An Bord Pleanála Oral Hearing

Irish Water

Greater Dublin Drainage

Response to Inspector's Questions

Figure 2-4: Planning Permissions adjoining site of Proposed RBSF Component

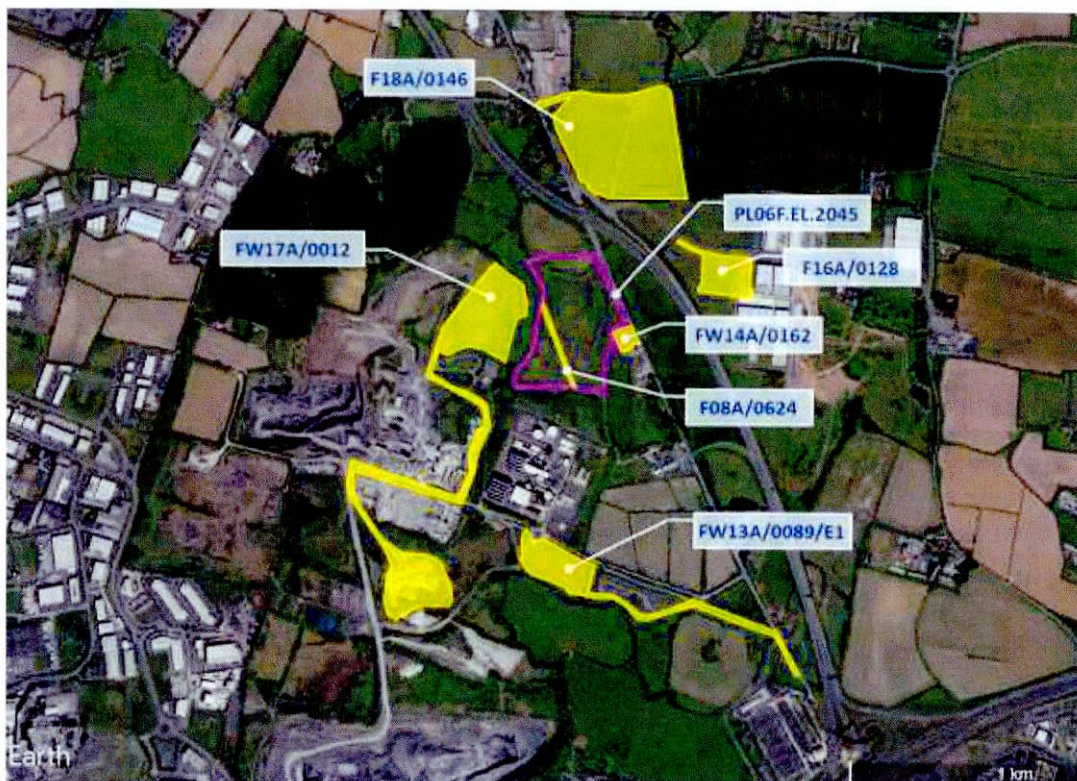
- 5 It is noted that a planning application (Ref. FW18A/0038 – amendments to previously approved application FW14A/0162 – was lodged and granted permission in 2018. The application related to amendments to FW14A/0162 which consisted of six residential units and a community facility, and was for the addition of a detached building which would accommodate 2 residential units in a single storey building of 99.8m². The application was granted permission by FCC on 9 May 2018.

Having considered the nature and scale of the permitted development, this planning application is regarded as a minor subsequent amendment to the parent permission (FW14A/0162) which was already previously assessed as described in the EIAR. It is considered that the slightly revised permitted development would have no impact on the assessment already undertaken and reflected in the submitted EIAR.

Figure 1: Location and Context of the Darndale 110kV and Belcamp 220kV and 110kV Substations

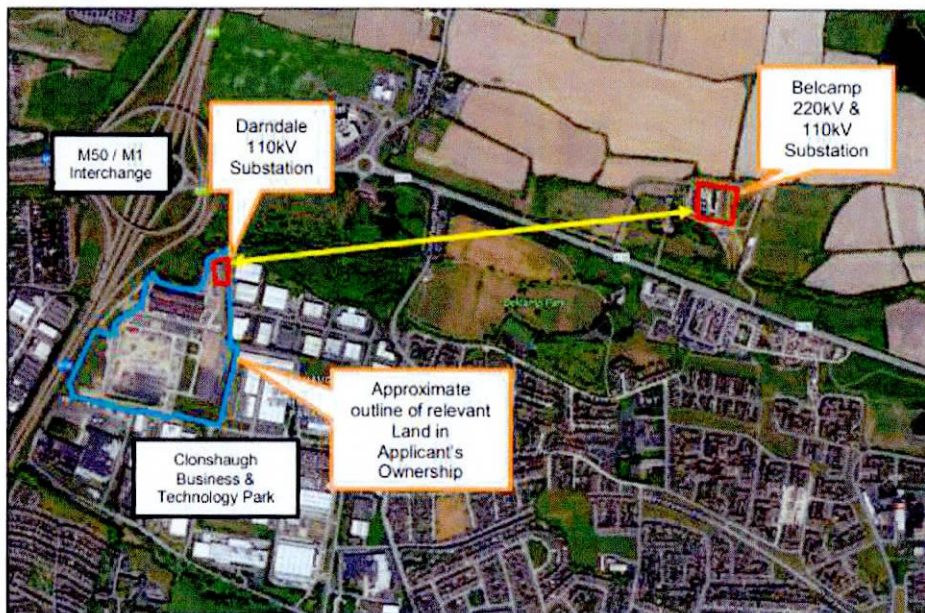
- 8 In undertaking a planning search in respect of this substation, it is noted that following a SID pre-application consultation process (Ref. PL29N.300793), a further SID application has been submitted to ABP. This application was lodged on 11 February 2019, by Amazon Data Services Ireland Ltd (ADSIL), for a double circuit 110kV underground transmission line between the Belcamp 220kV and 110kV substation and the Darndale 110kV substation. This application is due to be decided by ABP by 08/08/2019. The context and location of this development proposal is illustrated in the diagrams copied below and extracted from the submitted ADSIL SID Planning Report.

- The proposed development is located to the south of the existing Belcamp substation and thus in excess of 315m south of the proposed WwTP;
- It will be located on the opposite side (south) of the proposed realigned east-west distributor road.
- The trench works (requiring closure of one or more traffic lanes) associated with the proposed underground transmission line are proposed to be undertaken in the R139 carriageway at night, between 7pm and 6am.
- The proposed undergrounded cable route has no interaction nor impact on the Proposed Project (GDD) route or its above-ground elements, and will be situated outside of the Proposed Project access route (from the R139) and wayleave area.

The subject planning application is not therefore considered to provide any new material which would alter any of the assessments or findings already undertaken and presented in the EIAR.
